Hidden Lake Estates Homeowners Association Membership Meeting

SUBJECT: Site Observation of Bull Frog Reservoir; ID#01296; File#B-23; Cert.#35208

DATE: 8-16-2021

Figure 15-4 Standard Riprap Section

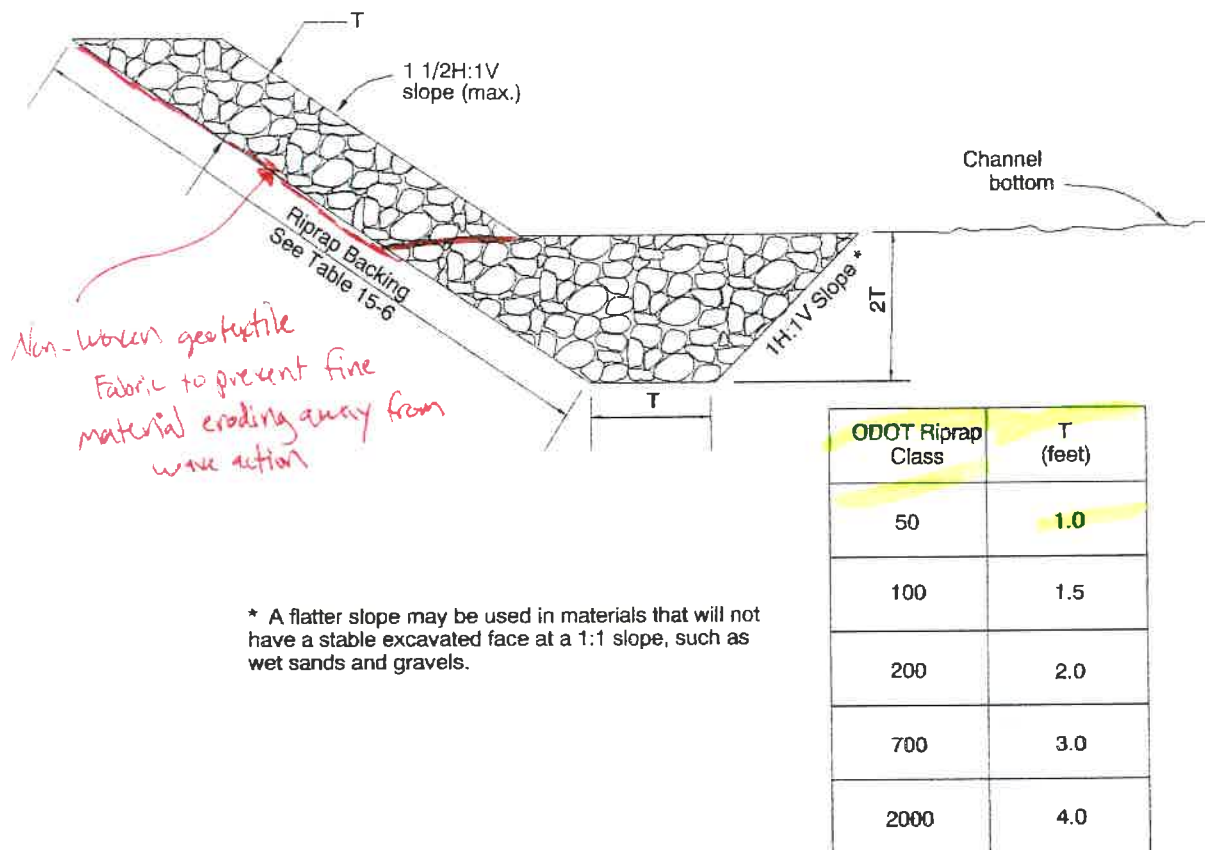
The owners are also proposing to install some erosion control measures to help prevent erosion from wave action. The owners are proposing to install ODOT Class 50 Rip Rap near normal pool elevation to help prevent erosion from wave action. Wave heights are not expected to reach higher than 1± foot. The contractor will likely excavate a bench for the rip rap layer, then install non-woven geotextile fabric (retains fine sediment particles from eroding away by wave action between rocks), then install the ODOT Class 50 Rip Rap approximately 1' minimum in depth. Refer to ODOT specifications at the end of this report.
